BEFORE THE ARIZONA POWER PLANT AND

IN THE MATTER OF THE APPLICATION  
OF SOUTHERN CALIFORNIA EDISON  
COMPANY AND ITS ASSIGNEES IN  
CONFORMANCE WITH THE  
REQUIREMENTS OF ARIZONA REVISED  
STATUTES SECTIONS 40-360.03 AND  
40-360.06 FOR A CERTIFICATE OF  
ENVIRONMENTAL COMPATIBILITY  
AUTHORIZING CONSTRUCTION OF A  
500kV ALTERNATING CURRENT  
TRANSMISSION LINE AND RELATED  
FACILITIES IN MARICOPA AND LA PAZ  
COUNTIES IN ARIZONA ORIGINATING  
AT THE HARQUAHALA GENERATING  
STATION SWITCHYARD IN WESTERN  
MARICOPA COUNTY AND  
TERMINATING AT THE DEVERS  
SUBSTATION IN RIVERSIDE COUNTY,  
CALIFORNIA

Docket No. L-00000A-06-0295-00130

**NOTICE OF FILING FINAL EIR/EIS EXCERPTS**

**Figure Ap. 1-2a  
North of Kofa Alternatives**

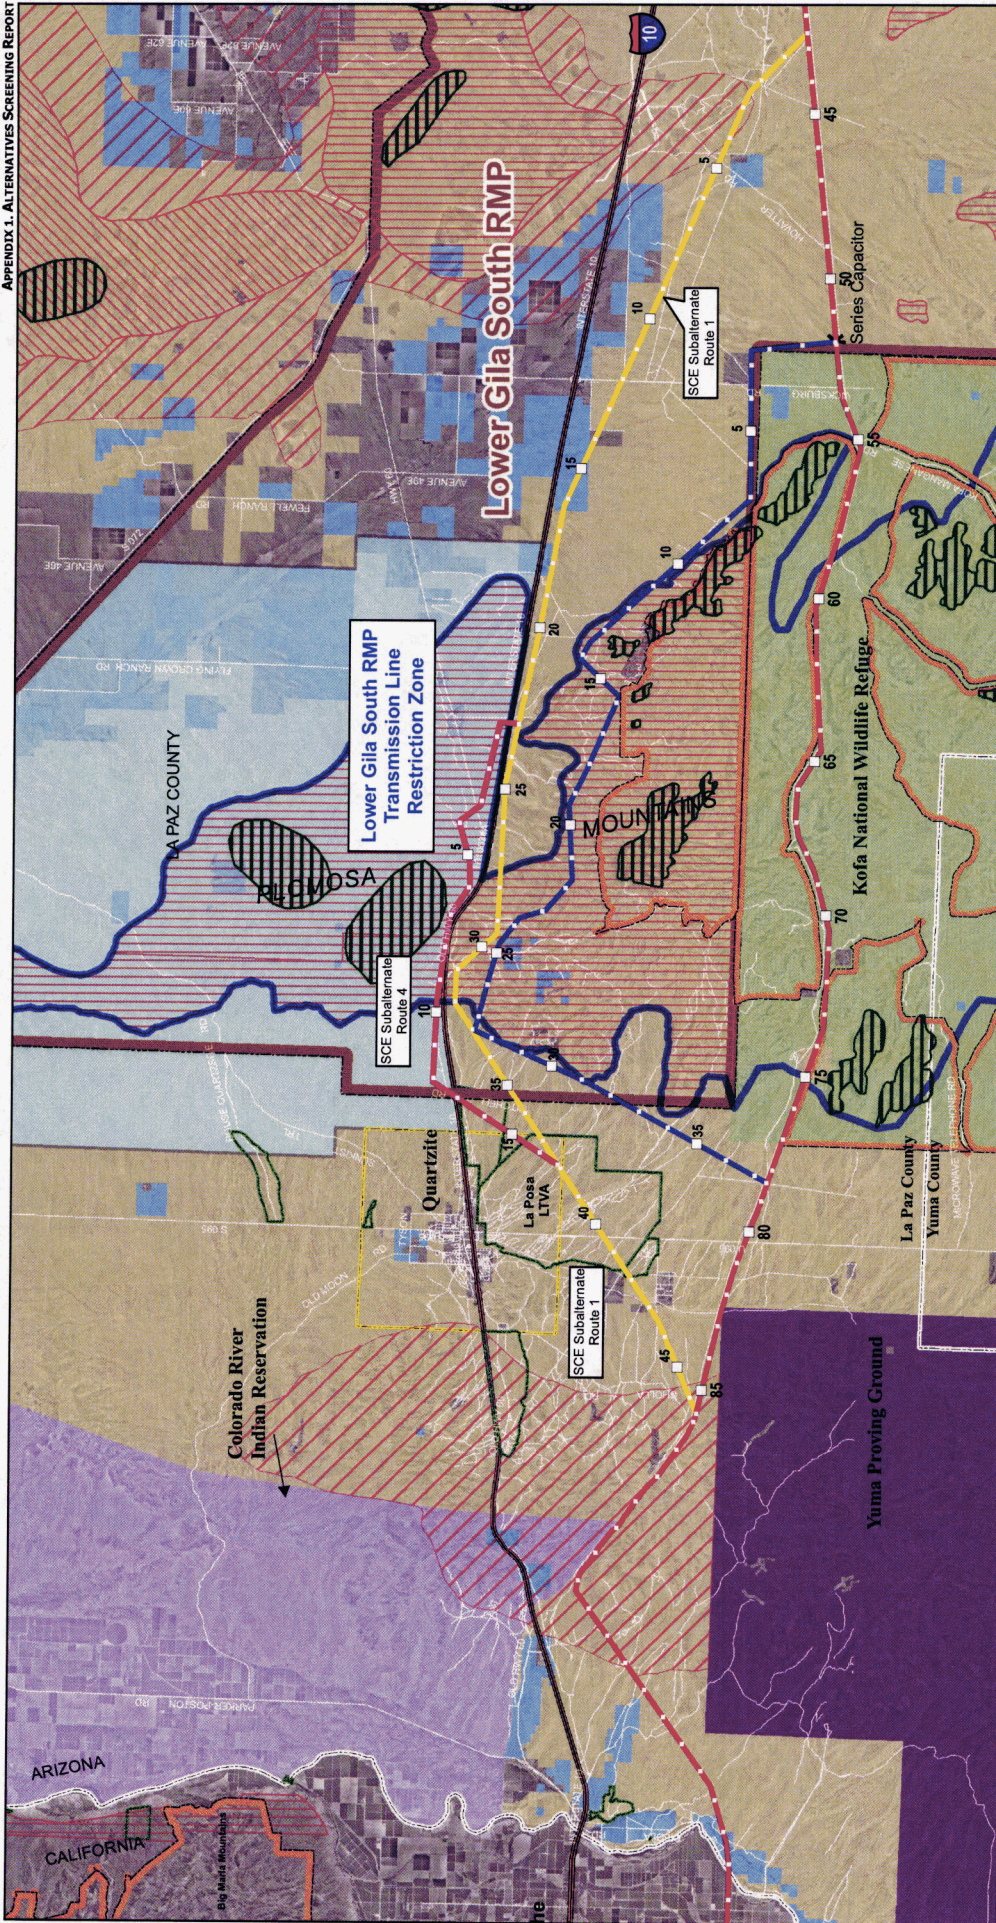
All three of the alternatives around Kofa NWR would be on BLM lands outside of established BLM utility corridors, and as such each of their approvals would require BLM approval for creation of a new utility corridor. Because the Resource Management Plans for the SCE North of Kofa NWR-South of I-10 Alternative and the North of Kofa Alternative routes do not specifically prohibit transmission lines in the area, a new ROW grant would be required, but a Plan amendment would not be necessary. This requirement would not make the two alternatives infeasible, but would add to the regulatory complexity of them.

However, approval of the SCE North of Kofa NWR-North of I-10 Alternative would require an amendment to the Lower Gila South RMP. The Lower Gila South RMP prohibits overhead lines north of I-10 between townships 16W and 18W (BLM, 1985) due to sensitive lambing grounds for bighorn sheep and sensitive visual resources. The requirement for a plan amendment may not make the alternative infeasible, but it would add a series of regulatory requirements.
